Adaptive vs. Programmable CTLE RX:

Cisco feedback

April 24, 2014

This presentation share our point of view about mode of operation of the module's input RX CTLE, as currently defined into IEEE draft 802.3bm/D2.2 and OIF_CEI_03.1.

Figure 83E-9—Example host output eye width and eye height test configuration

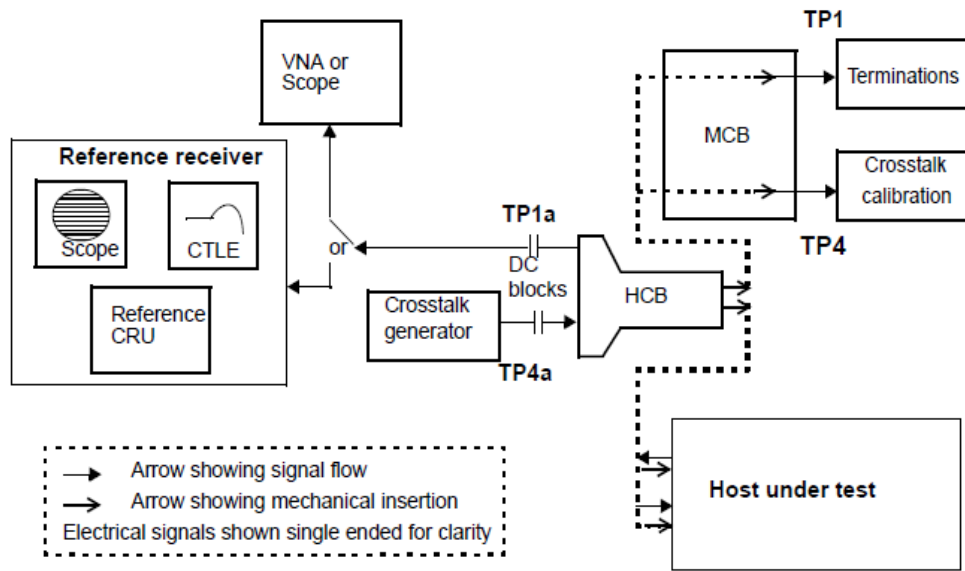
From 83.E.4.2 - Technical concern built assuming three equalizer's settings allowing TP1a compliance.

Figure 83E-15—Example module stressed input test

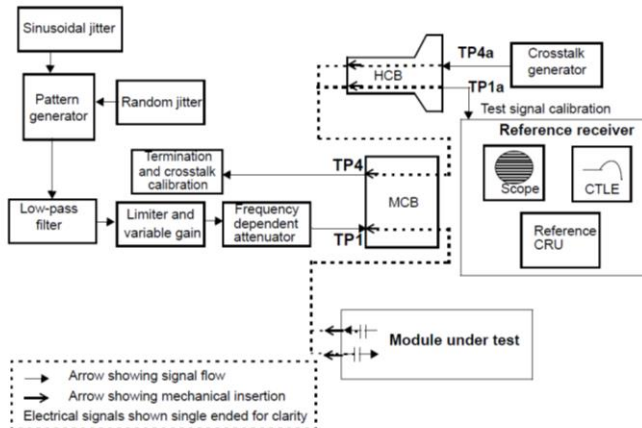
Should be clearly stated that the module has to meet EW and EH requirements at least for the *Recommended_CTLE_value* AND the +/-1dB cases ?

Note: this procedure is not needed for adaptive modules.

Figure 83E-10—Selectable continuous time linear equalizer (CTLE) characteristic

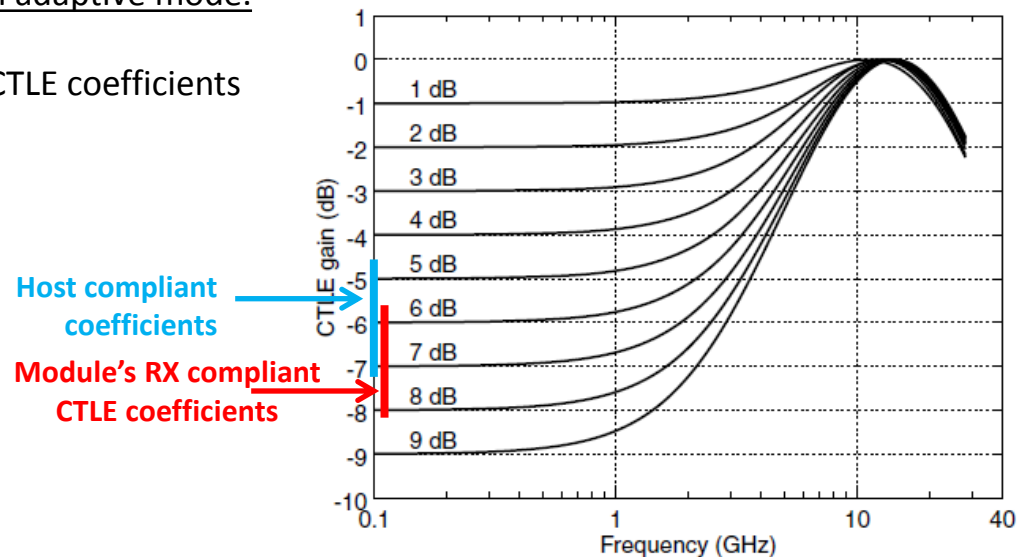
Potential link broken case when compliant host is mated to a compliant module.

Example – case of multiple points of compliance for host (TP1a) and module (TP1), under minimal IEEE compliance conditions.

For some port cases, the host is characterized and qualified to be TP1a compliant with multiple CTLE coefficients (e.g. 5,6 and 7dB, beyond IEEE request) – 6 is the optimum coefficient choose for IEEE implementation.

The module is also characterized and qualified by the module manufacturer to be IEEE TP1 compliant with CTLE RX coefficient setting to 6, 7 and 8 dB, with the others being not compliant (or not tested).

The host write 6 (optimum value) to the module -> module's fall into a marginal compliance state.

Host/module ageing and environmental changed conditions make the channel (host TX and PCB + connector + module's PCB and RX) to degrade by 1dB.

The channel is broken because the module's RX coefficient during time became 7dB, but the host will not write into the module anymore-> link is broken, should worked with adaptive mode.

Even in case of re-programmability, the host doesn't have any info about the fact that 7 and 8 RX CTLE coefficients can be also used by the module.

Neither host and module are responsible for the link broken due to ageing -> responsibility is shared.

Failures can happen even assuming multiple points of compliances (beyond current IEEE requirements) for the host.

CTLE Variation Due to Poles/Zero Tolerance

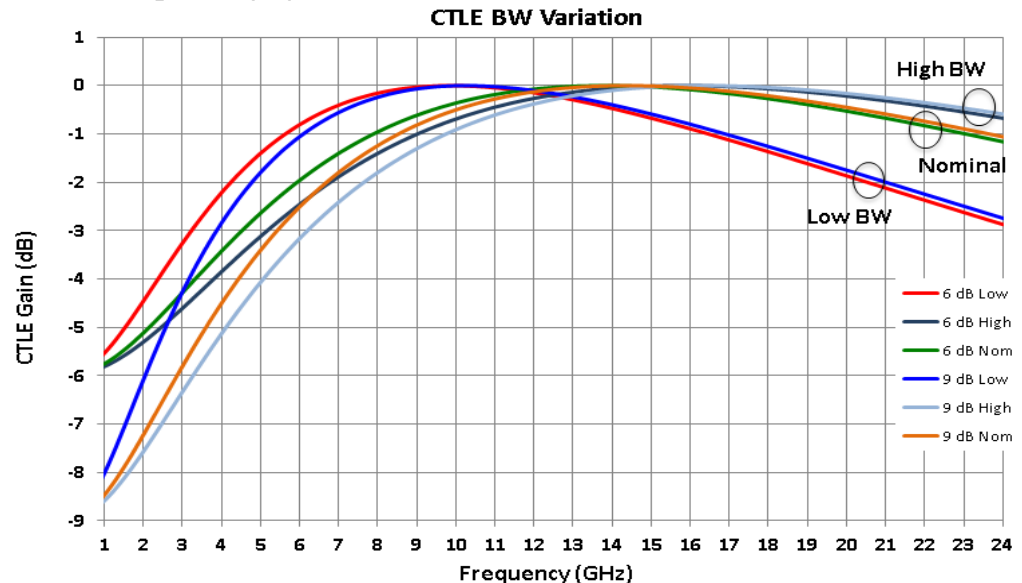
For the 6 dB and 9 dB peaking

- CTLE gain vary by ~ 0.5 dB

Figure 83E-10—Selectable continuous time linear equalizer (CTLE) characteristic

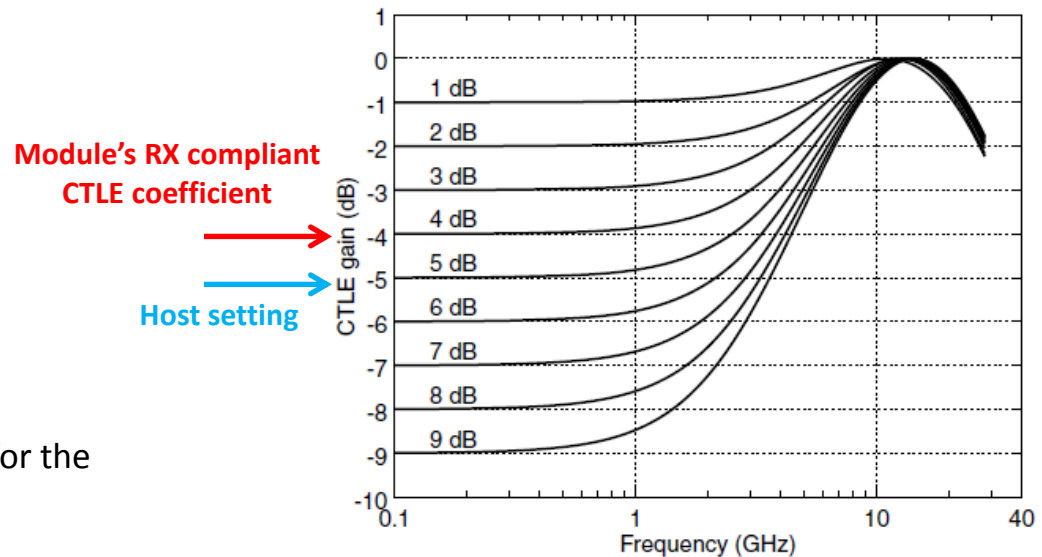
Potential link broken at start-up when an IEEE compliant host is mated to a compliant module.

Example – case of a single point of compliance for host (TP1a) and module (TP1).

For some port cases, the host is characterized and qualified to be TP1a compliant with just one CTLE coefficient (e.g. 5dB).

The module is also characterized and qualified to be compliant to a stressed input receiver (TP1), only when CTLE is set to 4dB is given to it.

Host write 5, module expect 4 -> link is broken, should have worked with adaptive mode.

Neither host and module are responsible for the link broken -> responsibility is shared.

Figure 83E-10—Selectable continuous time linear equalizer (CTLE) characteristic

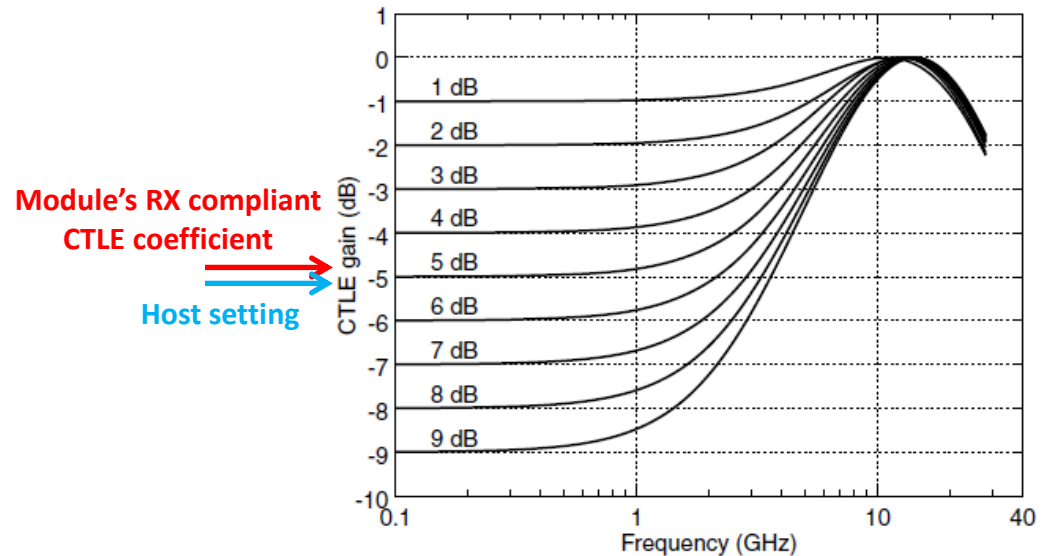
Potential link broken at start-up when compliant host is mated to a compliant module.

Example – single point of compliance, case of module and hosts CTLE coefficient mismatch.

For some port cases, the host is characterized and qualified to be TP1a compliant with one CTLE coefficients (e.g. 5 dB). The module is also characterized and qualified to be compliant to a stressed input receiver, when CTLE is set to 5dB, too. The way in which the host and module's manufacturer verify compliance makes 1dB mismatch between the two methods - the host should have a 6dB coefficient (instead of 5dB) to the module, to make it working.

(e.g. TP1a host characterization is done leveraging a reference receiver which will typically implement a CTLE filter mathematically, thus an ideal filter. This could lead to discrepancies with a real chip CTLE implementation, as reference receiver will not capture non-idealities and design tradeoffs built into the receiver. Besides this we have to take into account equipment tolerances, etc..),

The host write 5 (optimum value) to the module -> link is broken, should have worked with adaptive mode.

Responsibility still shared.
